Float / Ski Model  
2100, 2350, 3000 & 3450 Amphibious Floats

SERVICE LETTER #48

TITLE: Addition of Hydraulic Accumulator

TYPICAL INSTALLATION OF ACCUMULATOR HOSE – ALL MODELS

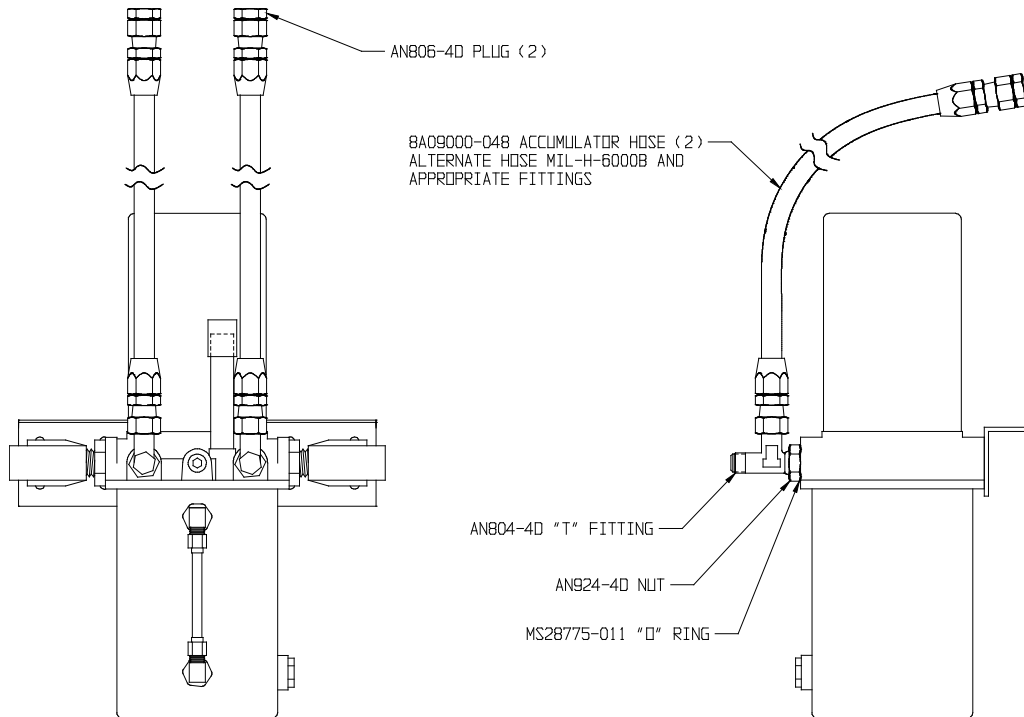
REASON: Aircraft experiencing "hydraulic lockup" (gear does not cycle up unless emergency gear selector handle is cycled) as evidenced by landing gear not retracting due to pressure buildup on back side of piston thereby not allowing opposite pressure switch to make contact.

METHOD OF COMPLIANCE: Add accumulators per Service Kit #32 and below illustrations.
